BEFORE THE SELWYN DISTRICT COUNCIL

IN THE MATTER OF Application RC 216016- to establish a
supermarket and associated facilities on
the corner of Levi and Lincoln Rolleston
Roads, Rolleston

EVIDENCE OF GABI WOLFER

ON BEHALF OF SELWYN DISTRICT COUNCIL

Figure 4-Shadow model (McCoy Wixon Architects)- Winter solstice 9 am

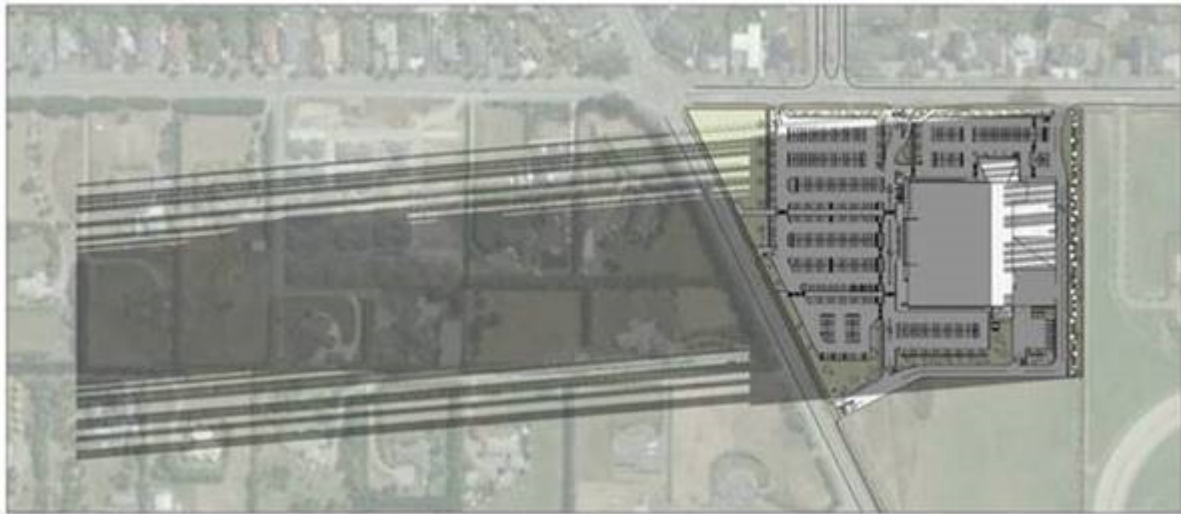
I have reviewed Mr Burns assessment in terms of effects of adjacent neighbours and the effects of the proposal in terms of visual amenity and shading. I have also requested the extent of the shading to be shown (see Figure 4 below) on the Lincoln Rolleston Road frontage and the residential sites to the West. This area sits within ODP area 9 and consists of larger Living Z zoned sections.

As shown in Figure 4 there will be shading effects on adjacent residential properties at certain times of the year and for a period of time due to the height and bulk of the proposal.

I consider that shading from the proposal will impact the current and future housing on these residential sections, which won't be able to be mitigated.

I consider that shading from the supermarket building along this boundary will impact current and future housing on residential sections along Lincoln Rolleston Road, as illustrated in above figure, which are likely not able to be mitigated due to height and bulk of the built form. I consider that similar effects could occur should the site be developed in accordance with the EHS Act and the MDRS being applied to development on site.

Figure 3- Location and Elevation Plans along Rolleston Drive consented Pak'n'Save

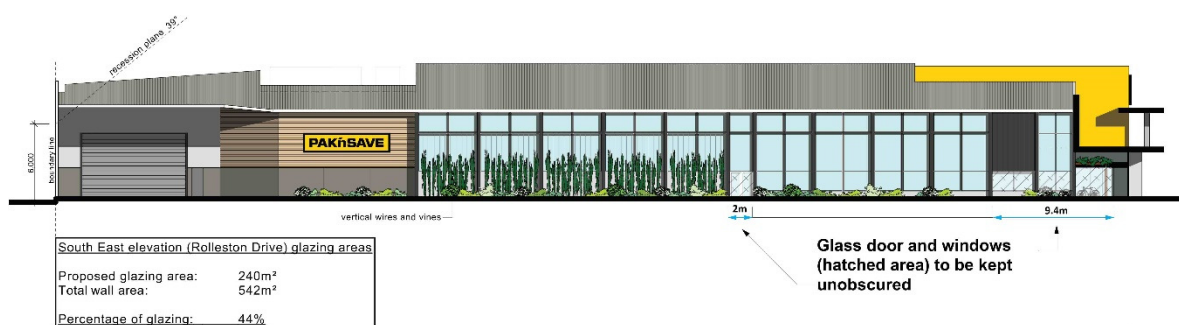
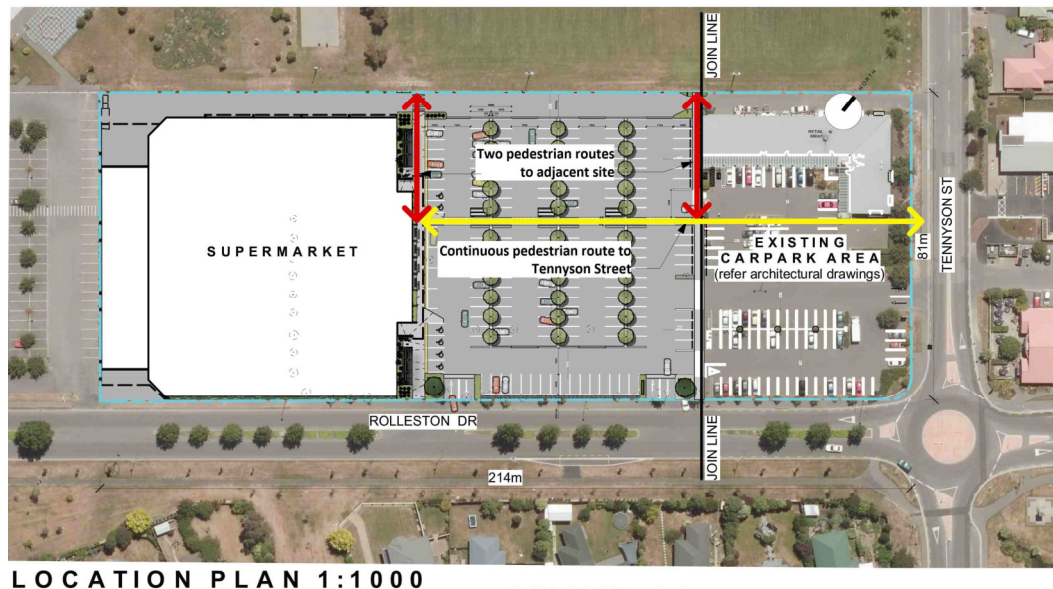
Having reviewed the site and elevation plans for the consented Pak'n' Save (see below) and it's layout I am unsure about Mr Burns assessment that there will be a blank wall along Rolleston Drive or open parking when in fact this proposal achieved not only an active frontage along public space (by providing 40% of glazing at Ground Floor level along Rolleston Drive), but has also subsequently placed car parking to the side of the building. Additional pedestrian routes were part of this consent ensuring an integration with existing shops and aligning with future routes under ODP 29C(i) as and when a connection to the new town centre could be facilitated, thus providing an opportunity to fully integrate the supermarket with the remainder of the town centre.

I consider these elements of active frontage and passive surveillance worth incorporating into the proposed design and have made recommendations to this effect in Section 6 below.

I disagree with the UD assessment in terms of the provision of active frontage within the previous consented Pak'n'Save on Rolleston Drive. In my opinion this proposal was a successful example of integrating a supermarket within a town centre context.
